Response to Information Request – Material Change of Use (Multiple dwelling and Short-term accommodation) – 8 Davidson Street, Port Douglas– Lot 704 on PTD2092

Date: 19 April 2024
Our Ref 47256RFI (1)
Development Application MCUC2024_5568/1 (Doc ID 1208441)
Approval Sought Development Permit
Property Address 8 Davidson Street Port Douglas
Property Description Lot 704 PTD 2092
Application Proposal Material Change of Use for Multiple Dwelling and Short-term Accommodation
Contact: Jenny Elphinstone

RESPONSE TO INFORMATION REQUEST ITEMS 1, 2, 3, 4 & 5

Figure 5 LiDAR Elevation Mapping

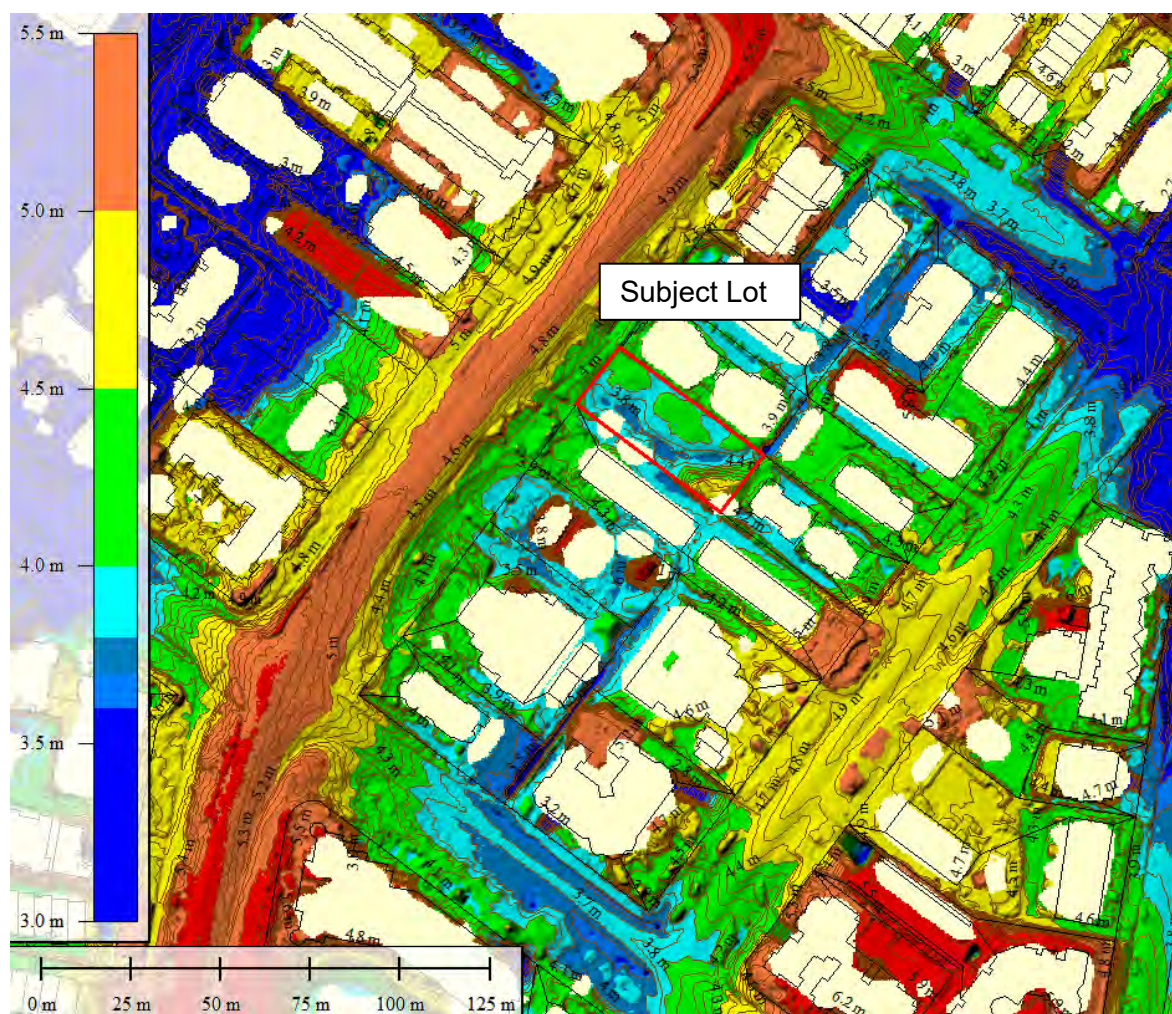
Please provide a local drainage study of the site to determine the drainage impacts on upstream and downstream properties and the mitigation measures required to minimise such impacts. In particular, the study must address the following:

The LiDAR elevation data indicates the following key features within the localised catchment:

- Within the “city block”, the lower elevated areas are generally along the rear allotment boundaries (areas in blue).
- A ridge exists along Davidson Street Road crown to the northwest from the subject site, defining the edge of this catchment (orange and red shading in Figure 5).

The lower elevated areas are generally the conveyance paths for overland flows in a 100-year ARI flood event. Refer to Figure 5, the lower elevated areas are shown in blue.

Figure 11 Proposed Development Plan by TPG Architects

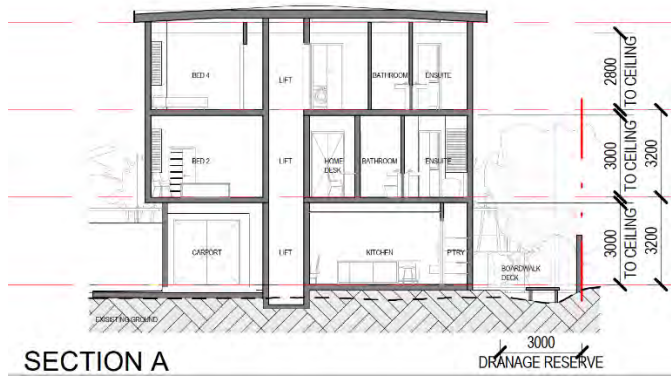
- b. *Existing sewer and stormwater infrastructure are situated in this rear area including a deep sewer manhole. Council requires the ability to maintain and service this infrastructure 24/7. This includes access to the sewer manhole and ability to work machinery freely in the easement area. Any gated access will need to be available to be opened for infrastructure servicing. All pool work needs to be designed having regard to the underground service infrastructure.*

The proposed BBQ deck and boardwalk within the easement area will be a lightweight, bolted timber and steel structure above ground level. The foundations can and will be founded at a depth that will not place load on or compromise the structural integrity of the existing sewer and stormwater infrastructure and are self-supporting if excavation to the sewer and stormwater network is required. The founded depth of any foundations will be outside the Zone of Influence.

The lightweight bolted deck structure can also be dismantled quickly and easily if required.

The proposal to adopt a revised boardwalk and elevated (suspended) deck allows for overland flow to pass under these lightweight structures within the drainage easement.

Figure 13 Extract of detail survey showing Pit 3

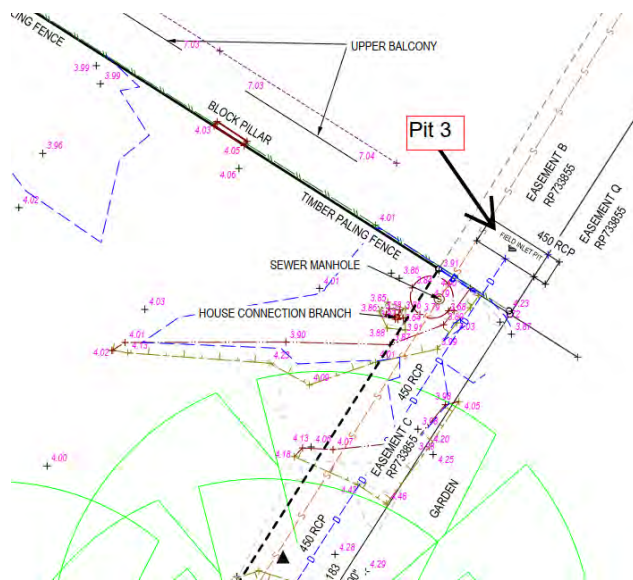
a. **The contributing catchment boundaries:**

Review of detailed survey, LiDAR elevation data and drainage network records by Council indicated that four inlet pits are located within the easement parcels along the rear of the subject site, connecting to a series of 450 mm diameter RCPs downstream.

Currently, runoff of the subject site appears to be captured by Pit 3 in the Lot immediately north from the subject site.

Figure 14 Detail Survey Markup

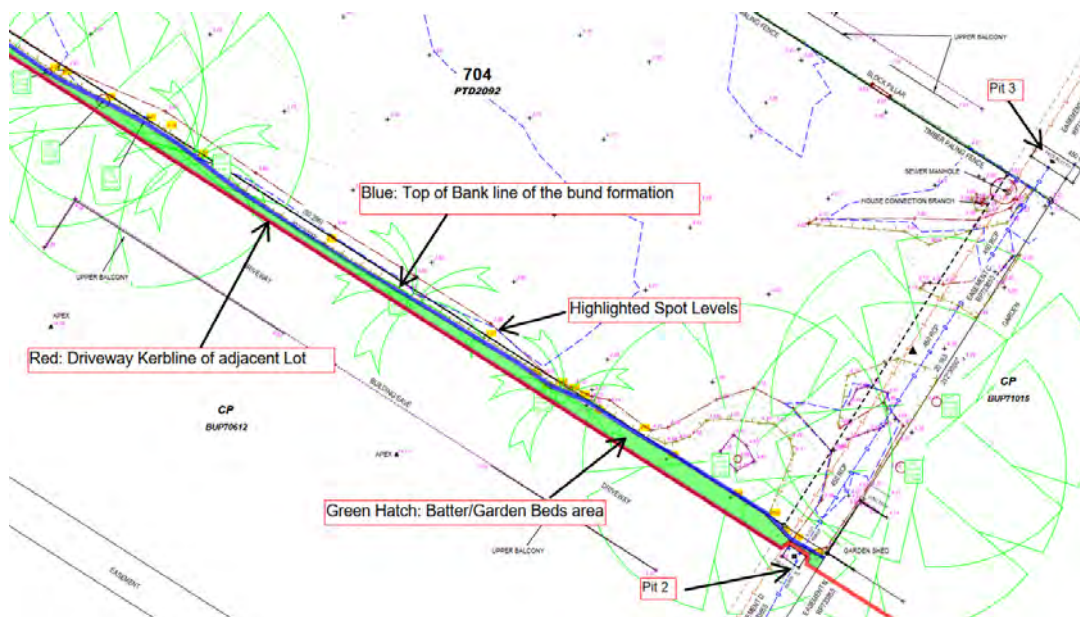
c. **Primary and secondary flow paths for the 5, 20, 50 and 100 year ARI flood events;**

South from the subject site is 10 Davidson Street. Within this lot, the driveway has a barrier kerb line and a raised garden bund formation.

It is understood that the kerb line and bund direct runoff from 10 Davidson Street into Pit 2 and prevent runoff from entering the subject site.

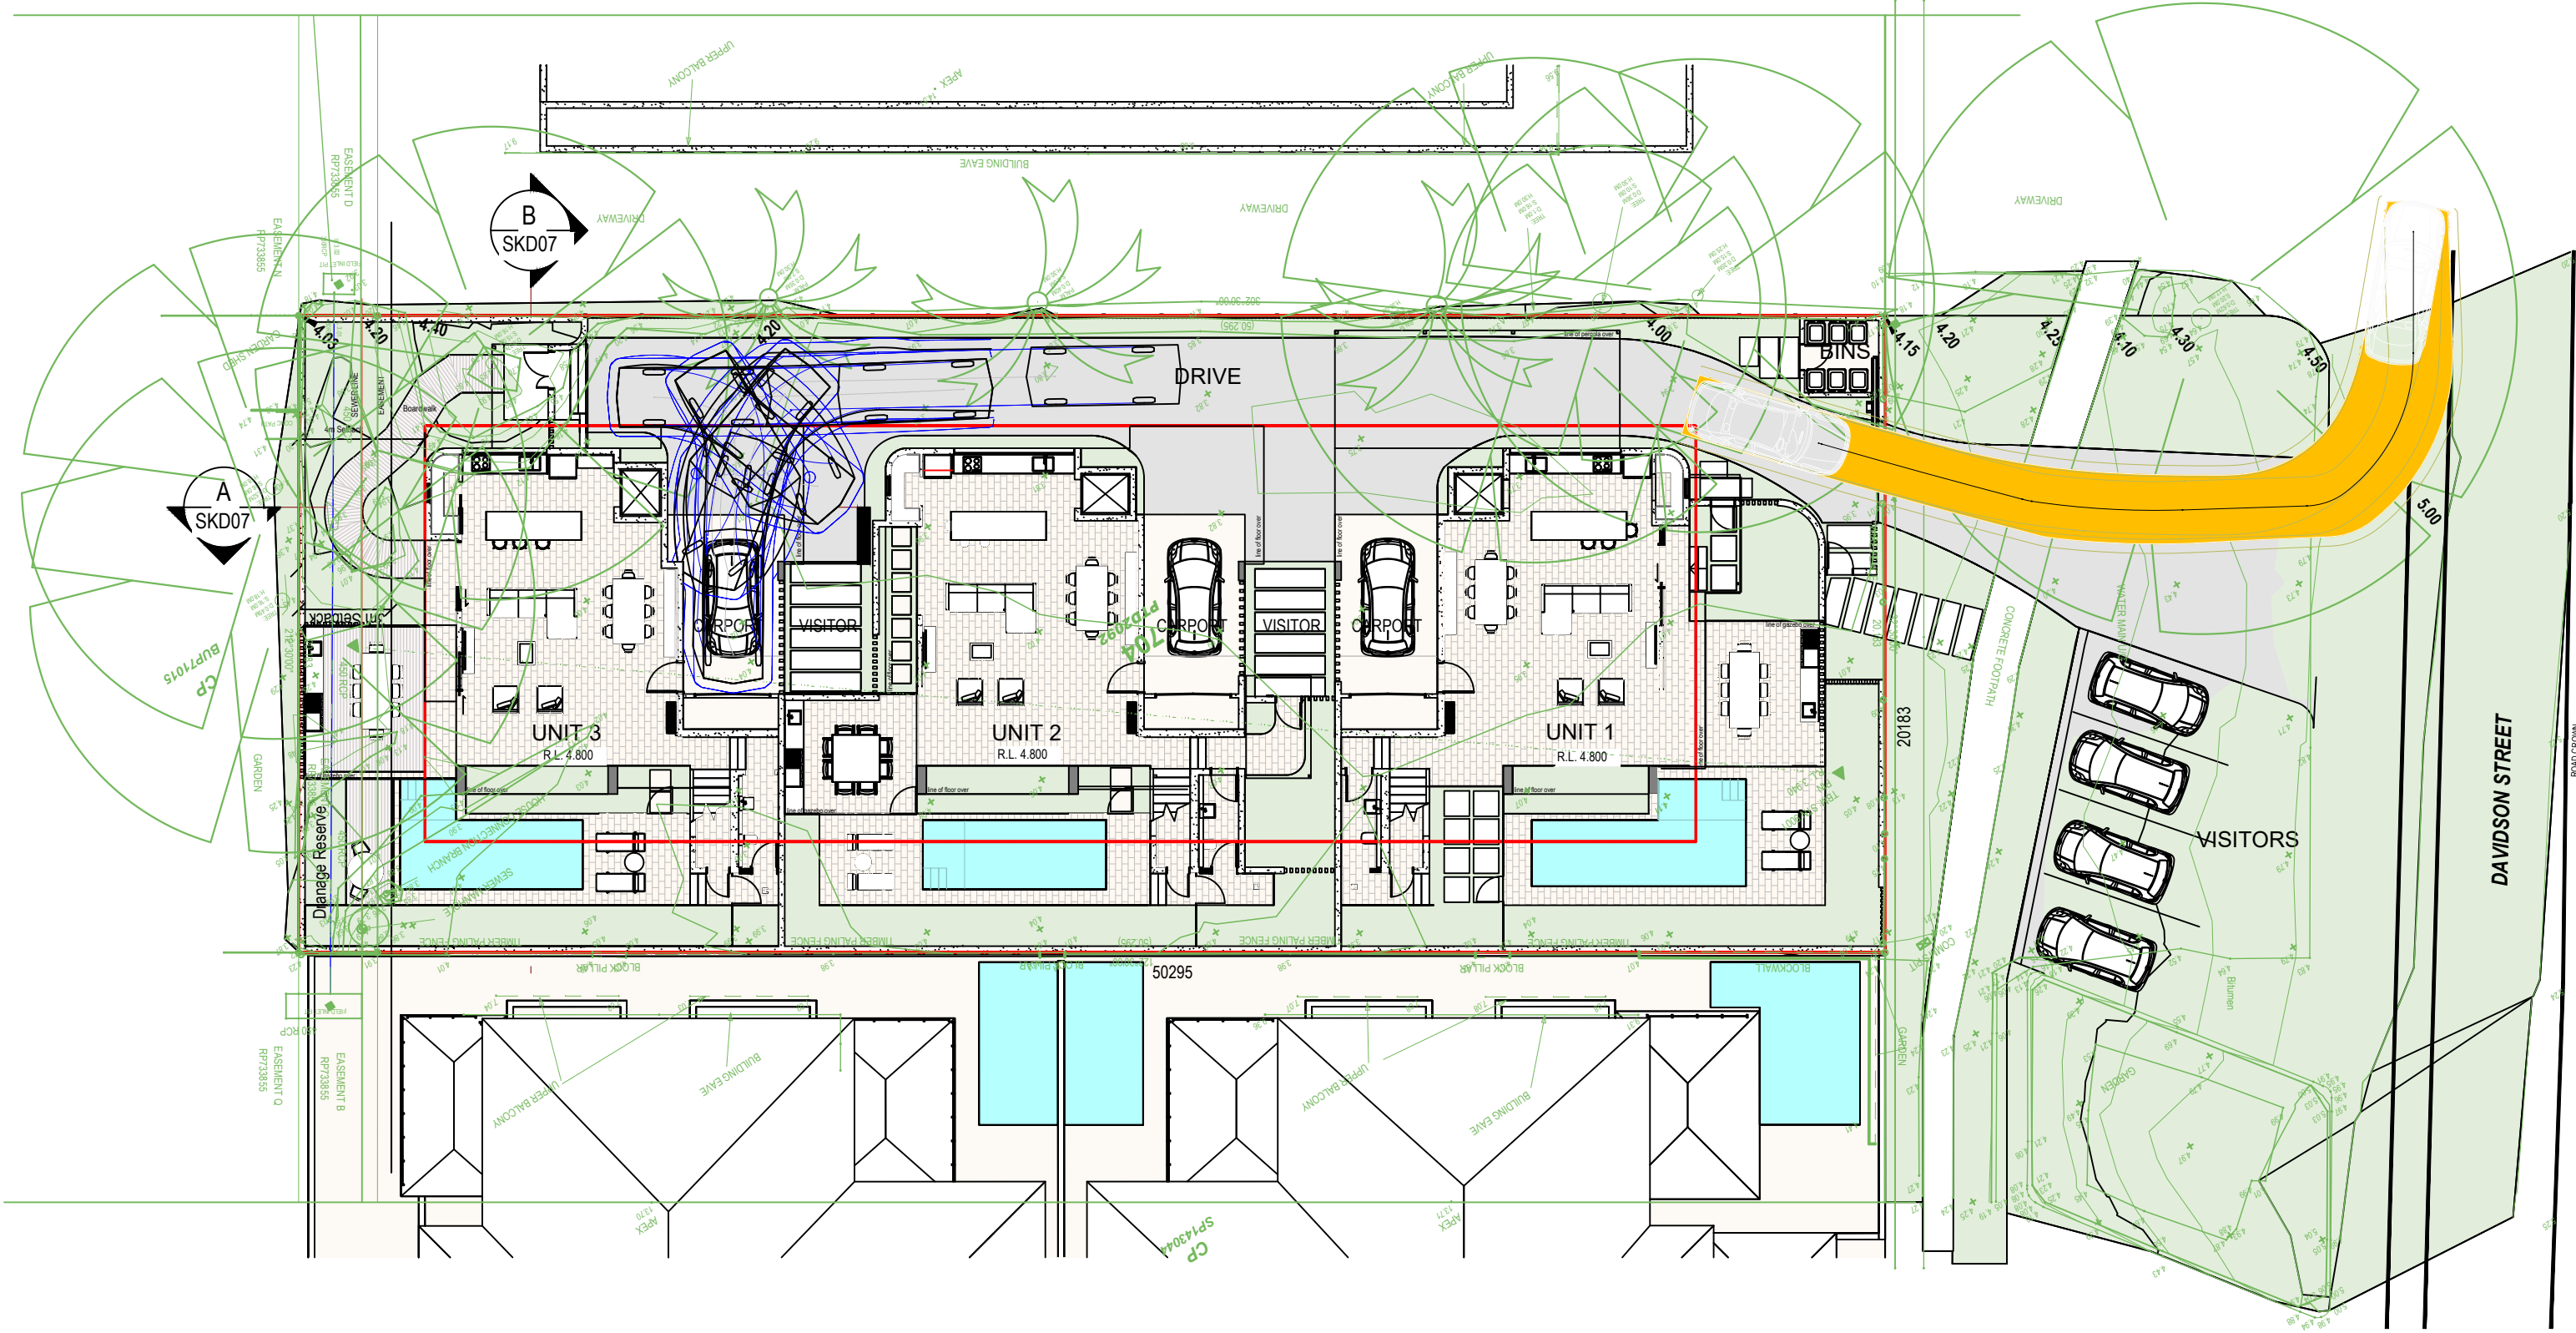
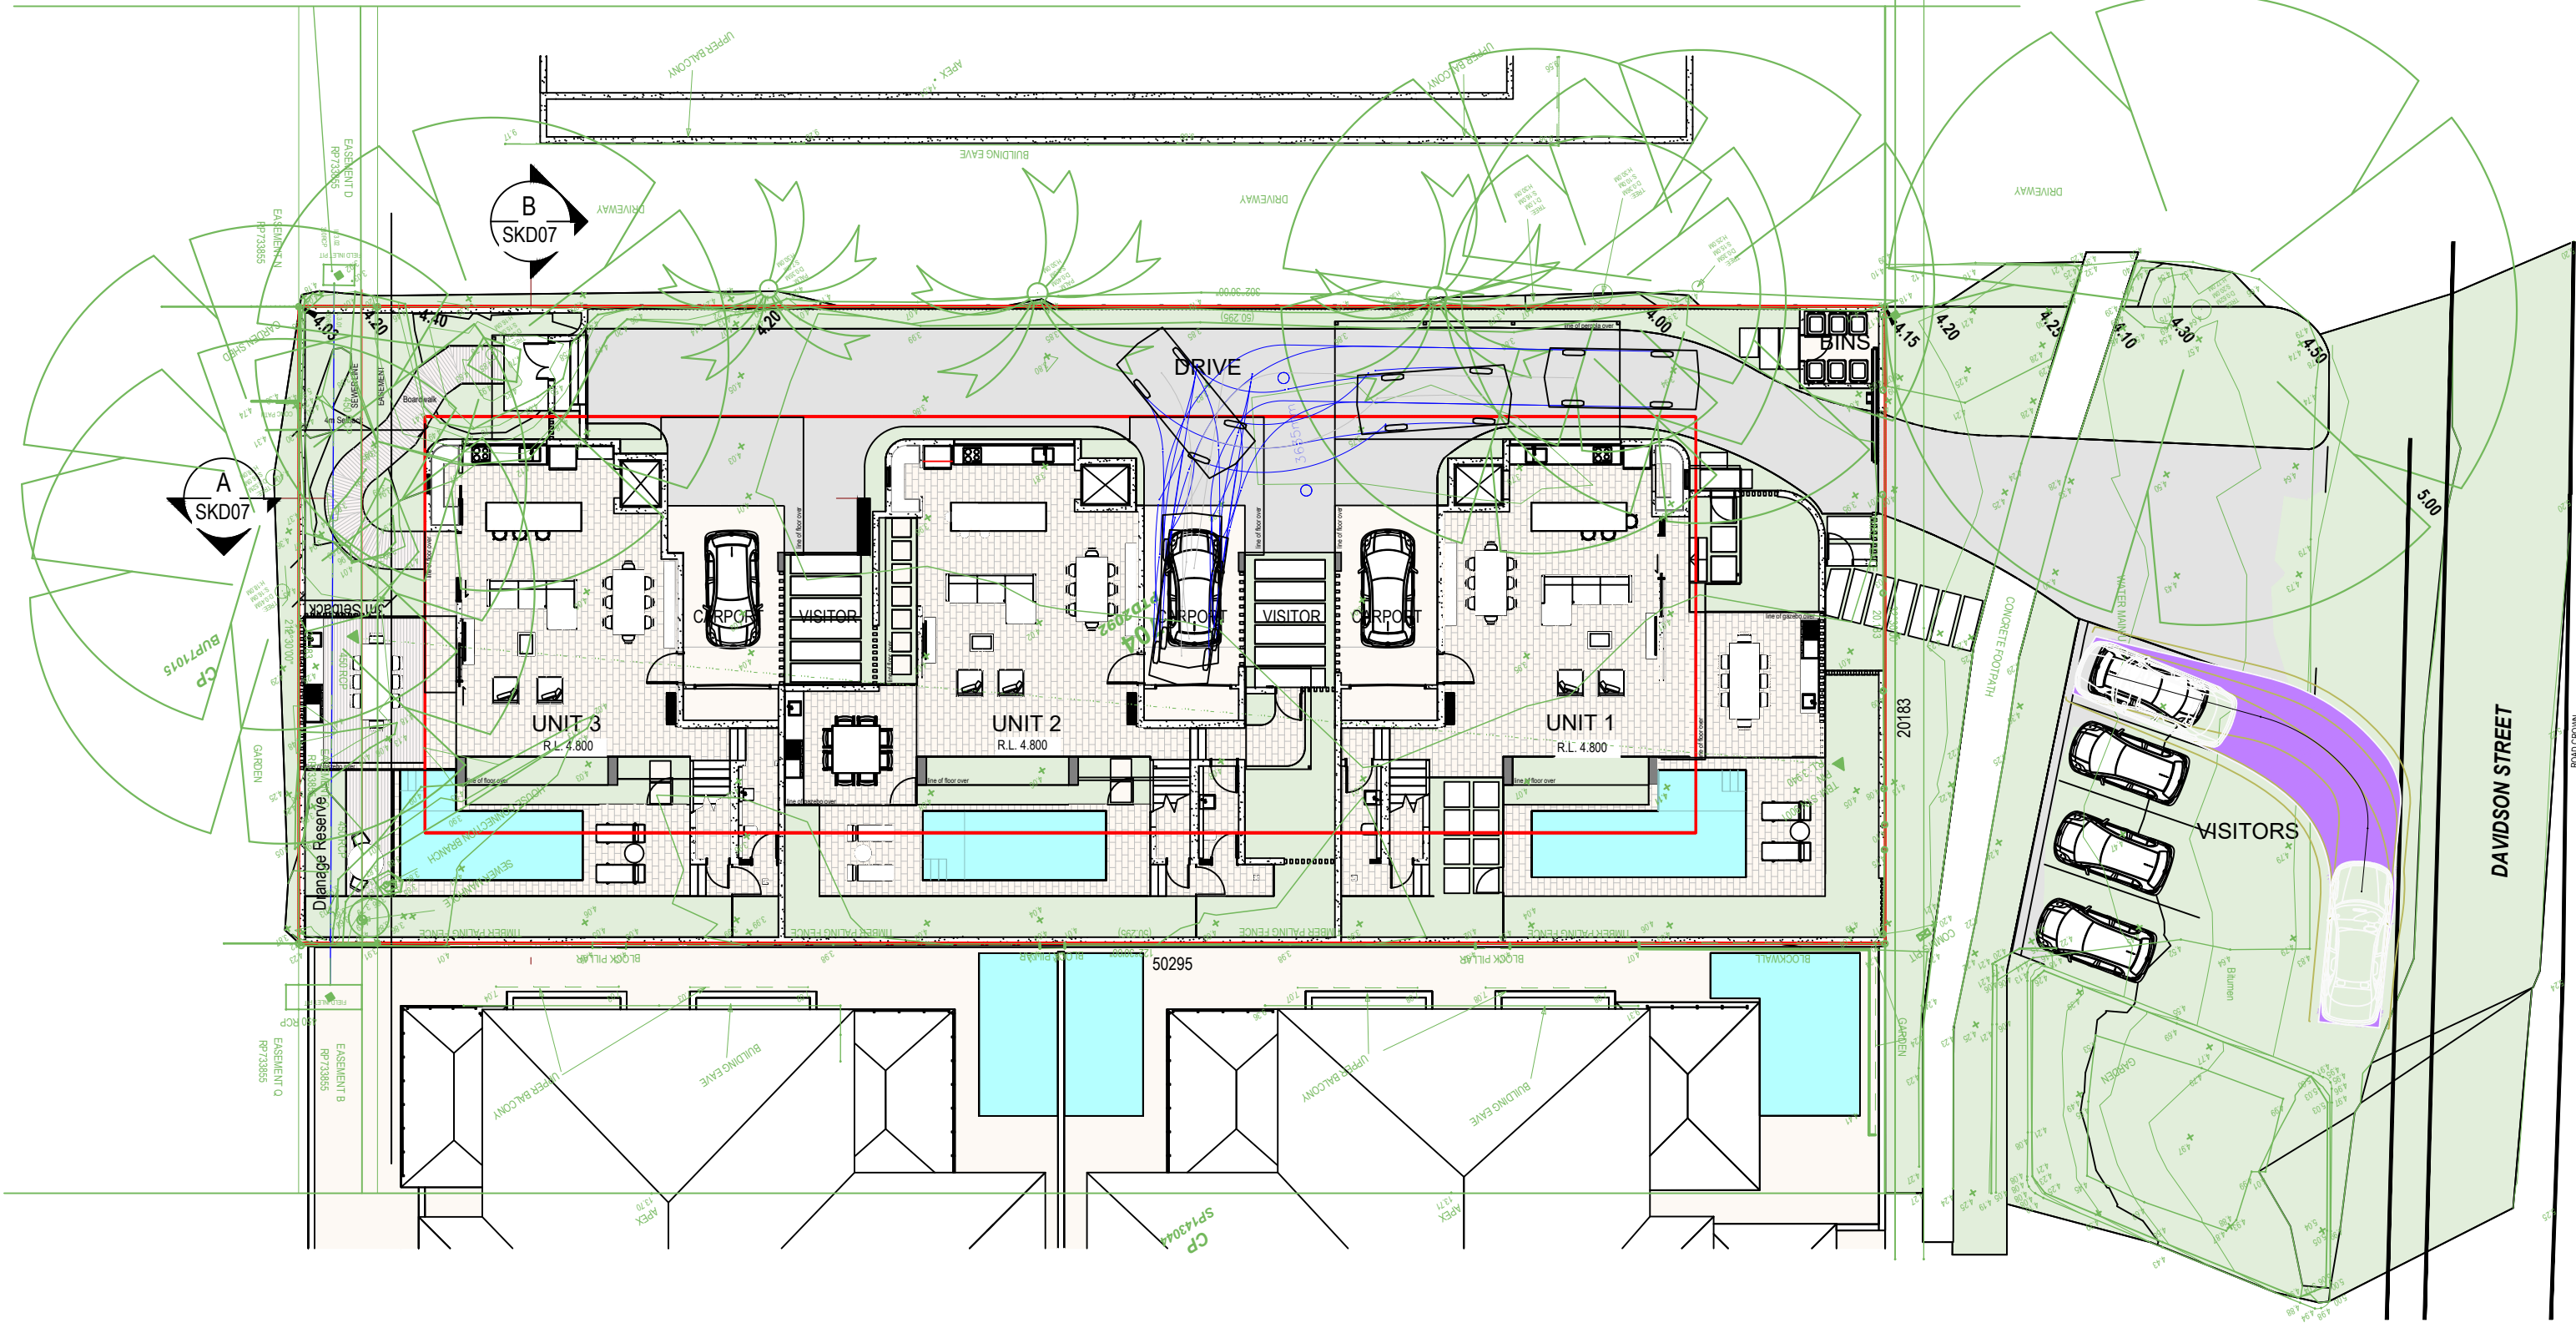
Please provide swept path turn details for proposed on-street parking spaces. Concern is raised with the rear turning interfering with the bicycle lane.

The swept path diagrams in Attachment A also show vehicular access to the internal car parks and garages. The access to internal carparks is serviceable and conforms with Australia Standard Codes.
